■INTERIOR

1. Instrument Panel

▶ 4WD Control Switch ◀

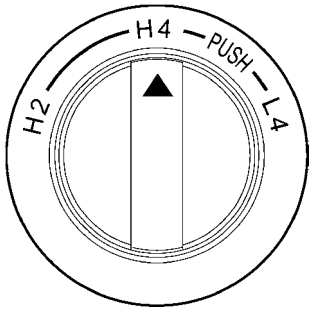
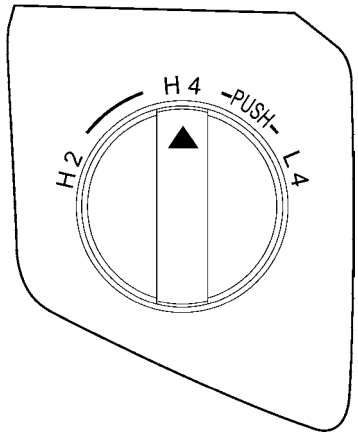
- Along with the changes to the shapes and arrangement of the switches on the instrument panel, the center cluster panel and center cluster lower panel have also been redesigned.
- The cigarette lighter socket has been eliminated, but two power outlet sockets have been provided instead.
- The bezel shape of the 4WD control switch has been changed. In addition, the bezel color has been changed from mat black to silver or glossy black to enhance the appearance quality.
- The panel color of the heater control panel assembly has been changed from silver to glossy black to enhance the appearance quality.
- The illumination colors of the components located on the instrument panel have been changed as follows to increase the cockpit stylishness.

▶ Door Trim for Double Cab ◀

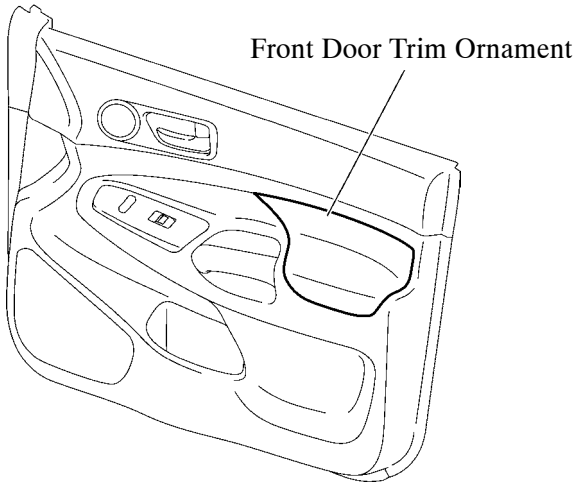
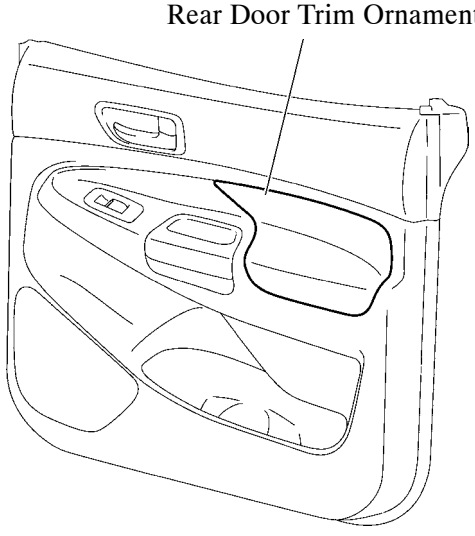
- The materials of the front door trim ornament and the double cab models' rear door trim ornament have been changed from fabric to Polyvinyl Chloride (PVC).
- The illumination color of the driver switch in the power window regulator master switch assembly has been changed from amber to greenish white to enhance the product quality.
- The bezel color of the power window regulator master switch and power window regulator switch assemblies has been changed from dark blue to black. In addition, the switch knobs have been changed to improve the product quality.
- The bezel color of the rear power window regulator switch assembly has been changed from dark blue to black, improving the product quality.

Overhead Console

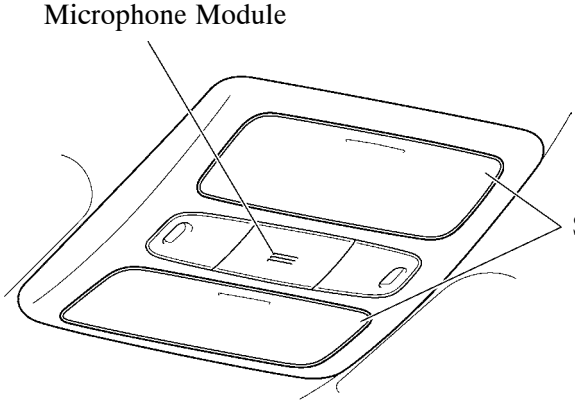
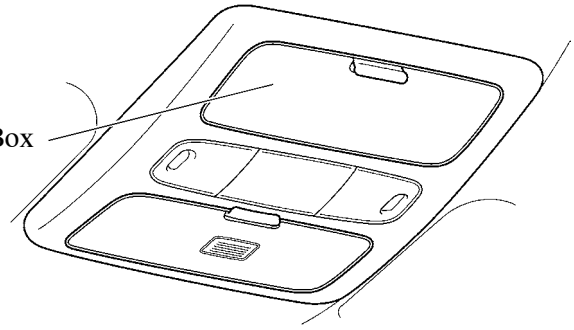
The overhead console, which is fitted on access cab and double cab models, has been changed.

- Since the accessory meter has been built into the inner rear view mirror, a box for storing small articles has been added.
- The microphone module installation position has been relocated from the inner rear view mirror to the overhead console.

Rear Console Box

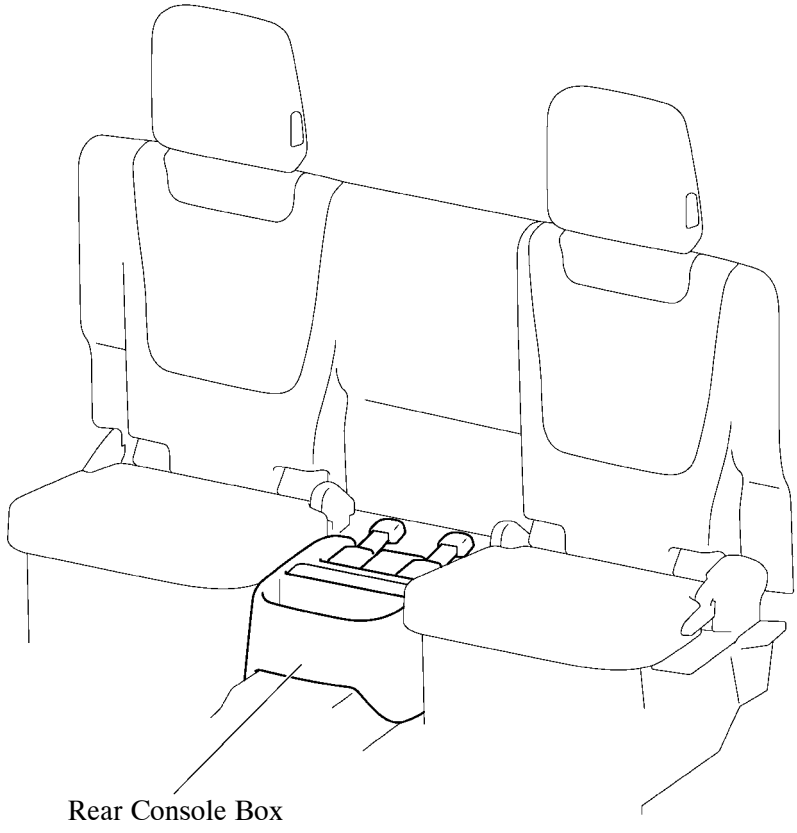
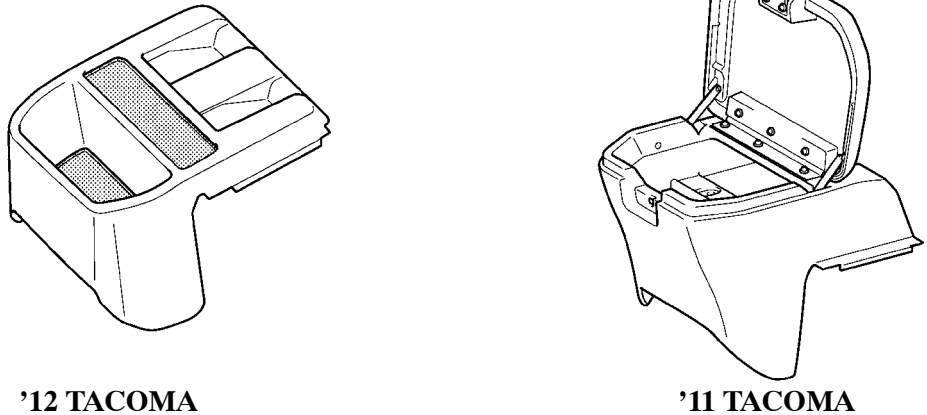
The rear console box, which is fitted on access cab models, has been changed. The lid has been eliminated, and a rubber mat has been newly provided.

4. Sun Visor

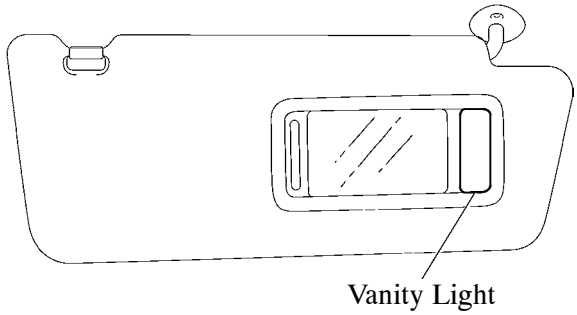
On OFF ROAD, SPORT, SR5 and X-Runner package models, a vanity light has been provided on both the driver's and front passenger's sun visors.

5. Shift Lever Knob

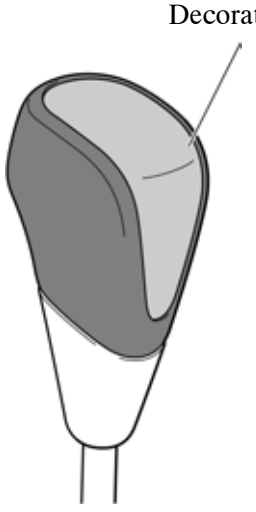
- The shift lever knob used on automatic transmission models has been redesigned.
- On OFF ROAD, SPORT, SR5 and X-Runner package models, a shift lever knob with decorated panel has been provided.

6. Floor Mat

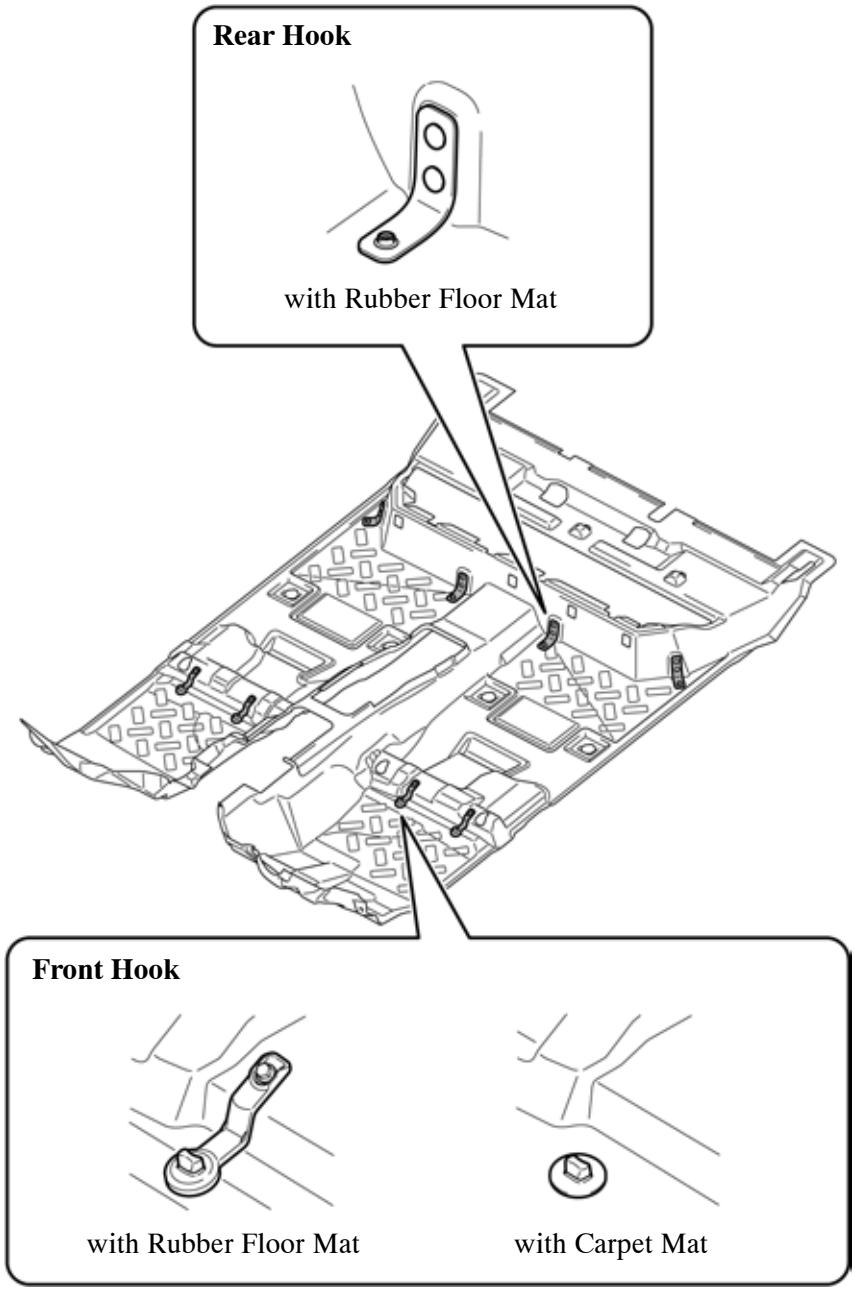
- The floor mats of all models have been equipped with hooks that can fasten optional dealer installed front floor mats.
- An optional rubber floor mat, which is made of Thermo Plastic Olefin (TPO) that has good properties to resist dirt, has been made available on X-Runner package models and long wheel base models with 1GR-FE engine. An optional rubber floor mat that is available only on long wheel base double cab models with 1GR-FE engine has another set of hooks in addition to the front hooks, that can fasten optional dealer installed rear floor mats.
